AMENDMENT NO. 2 TO
APPLICATION FOR AMENDMENT
TO OPERATING LICENSE

Technical Specification
Page Revisions

Consolidated Edison Company of New York, Inc.
Indian Point Unit No. 2
Docket No. 50-247
Facility Operating License No. DPR-26
February, 1985

INDIAN POINT UNIT NO. 2 COOLANT HEATUP LIMITATIONS
 APPLICABLE FOR PERIODS UP TO 15 EFFECTIVE FULL POWER YEARS

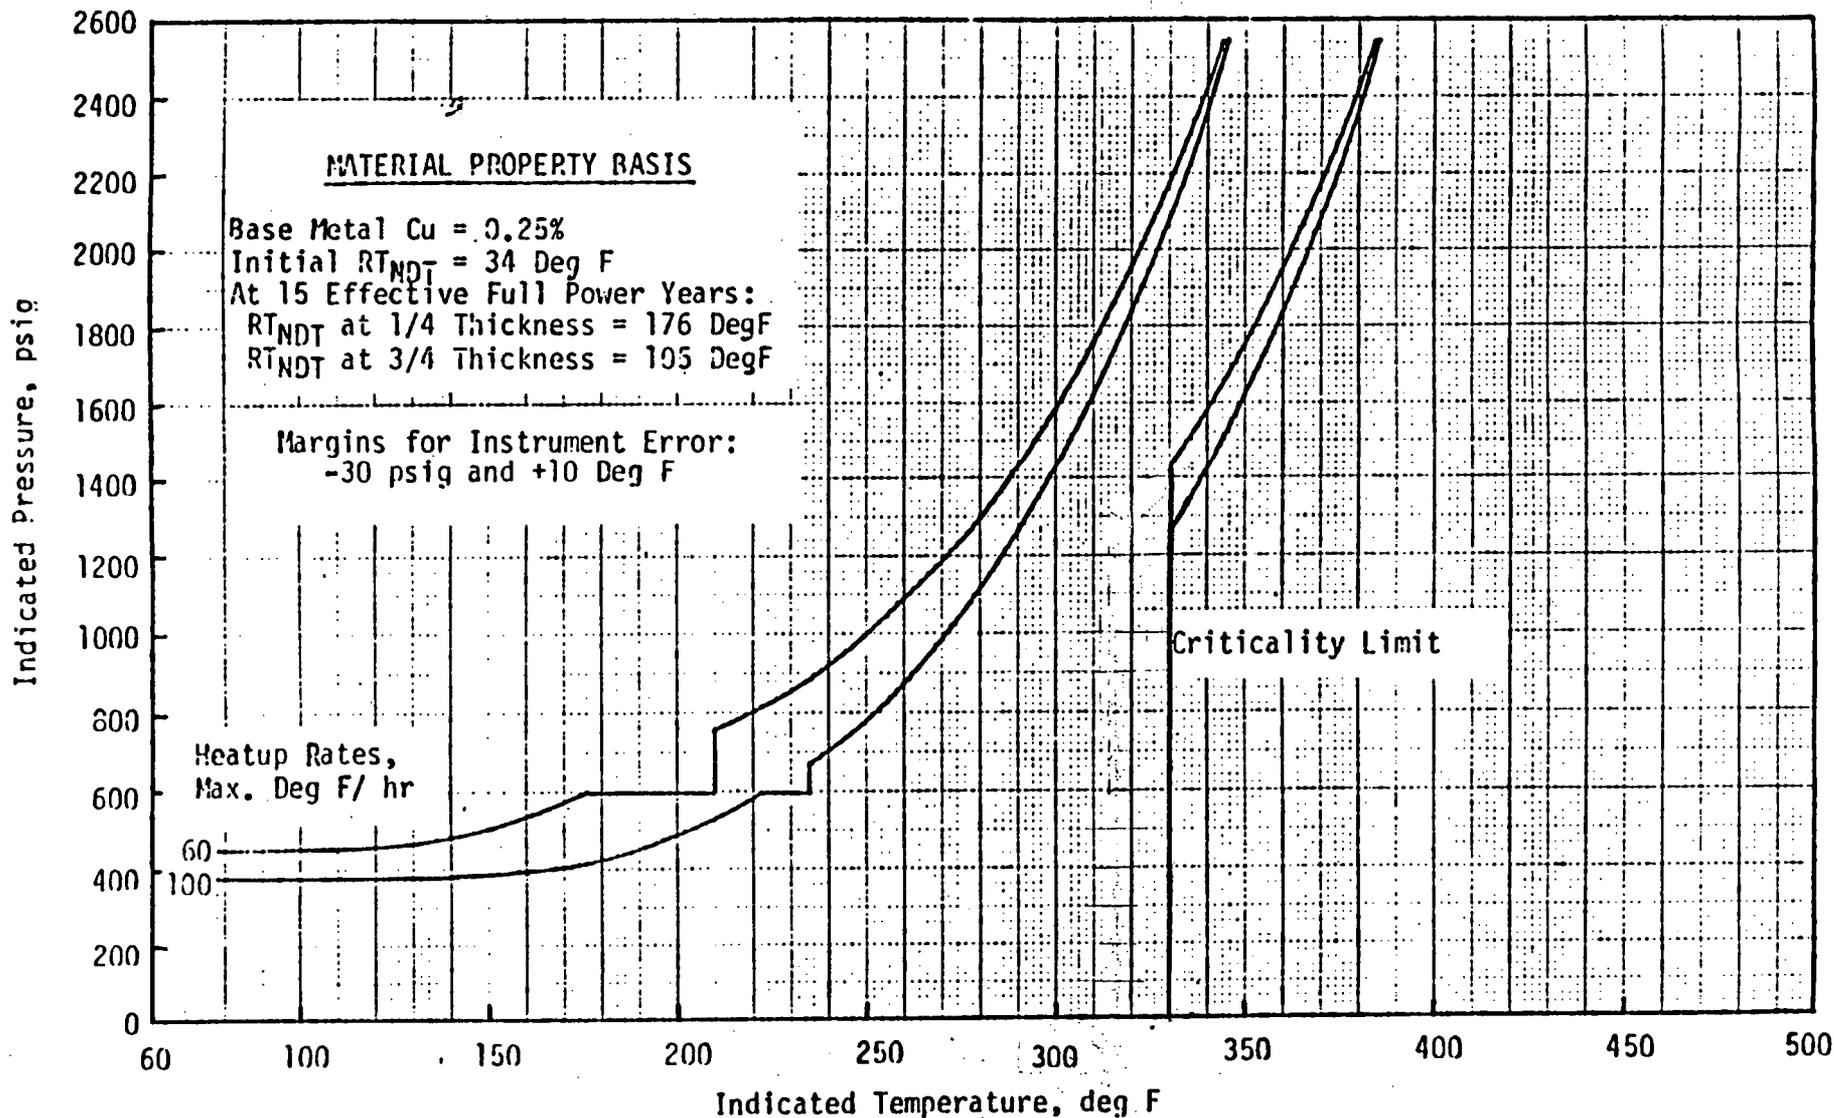
Sections 3.1.B and 4.3 of the present Indian Point Unit No. 2 Technical Specifications contain limitations for reactor coolant system heatup, cooldown and hydrostatic testing applicable through 7 EFPYs of reactor operation. Based on present projections, the Indian Point reactor is expected to exceed 7 EFPYs in July, 1985. The changes proposed to technical specification sections 3.1.B and 4.3 in this application will incorporate revised requirements applicable through 15 EFPYs. These new requirements are based on the testing and analysis of the most recent reactor vessel surveillance capsule (i.e., Capsule Z-removed during the 1982 refueling/maintenance outage). The final report on the capsule analysis entitled, "Reactor Vessel Material Surveillance Program for Indian Point Unit No. 2 Analysis of Capsule Z", dated April, 1984, was submitted to the NRC by Consolidated Edison letter dated May 7, 1984. For demonstrative purposes, that report contained heatup and cooldown curves and predicted shifts in RT_{NDT} for projected operation up to 32 EFPYs. The 15 EFPY limitations proposed in this application are based on the same data and analysis contained in the Capsule Z report for the 32 EFPY limitations. The revisions to Table 3.1-1 of the present technical specifications (contained in renumbered Table 3.1.B-1 of this application) regarding reactor vessel core region material are based on the detailed information provided to the NRC Staff by Consolidated Edison letter dated March 29, 1978 as applied in the Capsule Z report provided to the Staff on May 7, 1984. The net effect is that all heatup and cooldown limitations are now based on an initial RT_{NDT} of 34°F (vs. 60°F) for the controlling vessel plate material.

1. The reactor coolant temperature and pressure and system heatup and cooldown rates averaged over one hour (with the exception of the pressurizer) shall be limited in accordance with Figure 3.1.B-1 and Figure 3.1.B-2 for the service period up to 15 effective full-power years. The heatup or cooldown rate shall not exceed 100°F/hr.

Figure 4.3-1

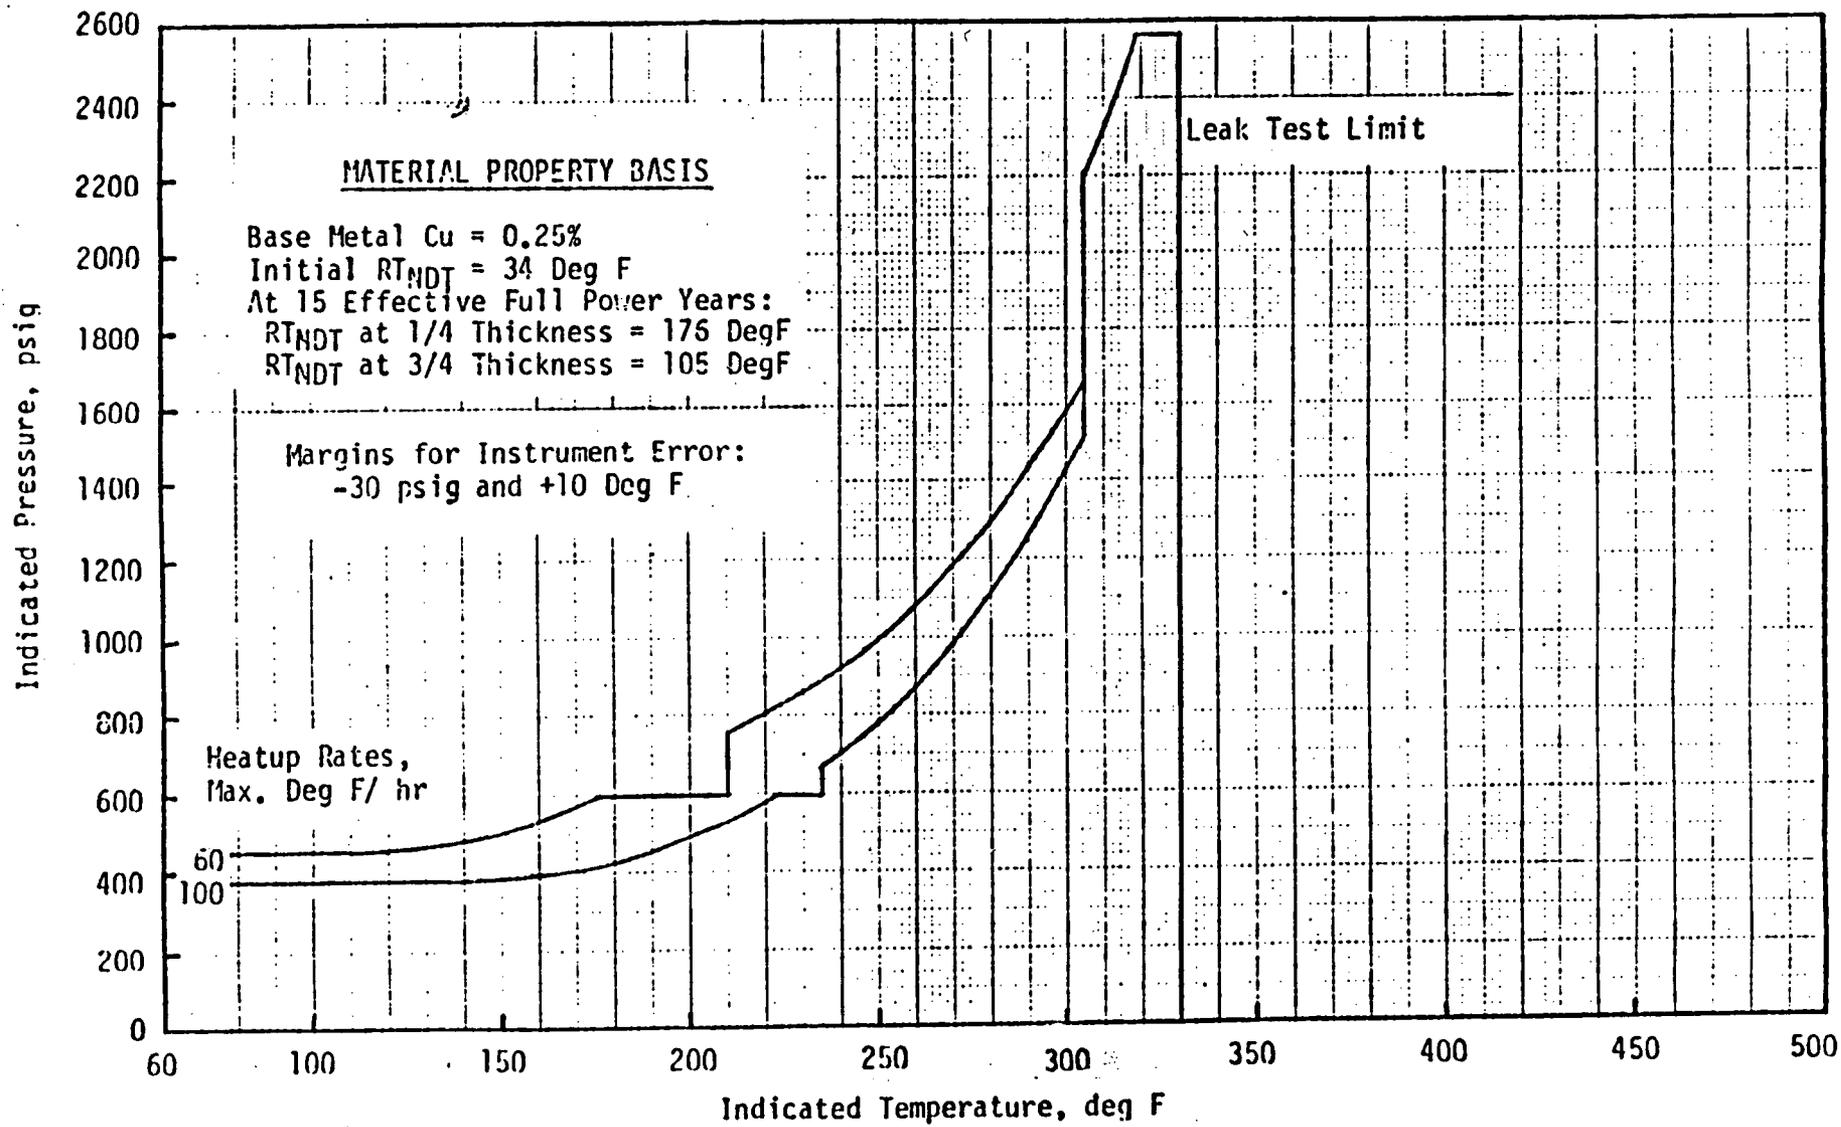
The new minimum temperature for the reactor coolant system hydrostatic testing window per Figure 4.3-1 is approximately 305°F. Thus, the overpressure protection system arming temperature has been accordingly revised to 295°F (i.e., 305°F - 10°F (error) = 295°F) and the maximum temperature for starting the first reactor coolant pump has been revised to 267°F (i.e., 295°F - 28°F (heat addition transient overshoot) = 267°F). These changes have been reflected in this Application as revisions to previously proposed (i.e., February 14, 1983) technical specifications 3.1.A.1, 3.1.A.4, 3.1.A bases, Table 3.1.A-2 and Figures 3.1.A-1, 3.1.A-2 and 3.1.A-3. The theory and analysis supporting these revised limits is the same as previously provided to the NRC Staff. Only the specific limiting values have changed to reflect the shift in the heatup and cooldown limitation curves.

For the first fifteen (15) effective full-power years, it is predicted that the highest RT_{NDT} in the core region taken at the 1/4 thickness will be 176°F. The minimum inservice leak test temperature requirements for periods up to fifteen (15) effective full-power years are shown on Figure 4.3-1.
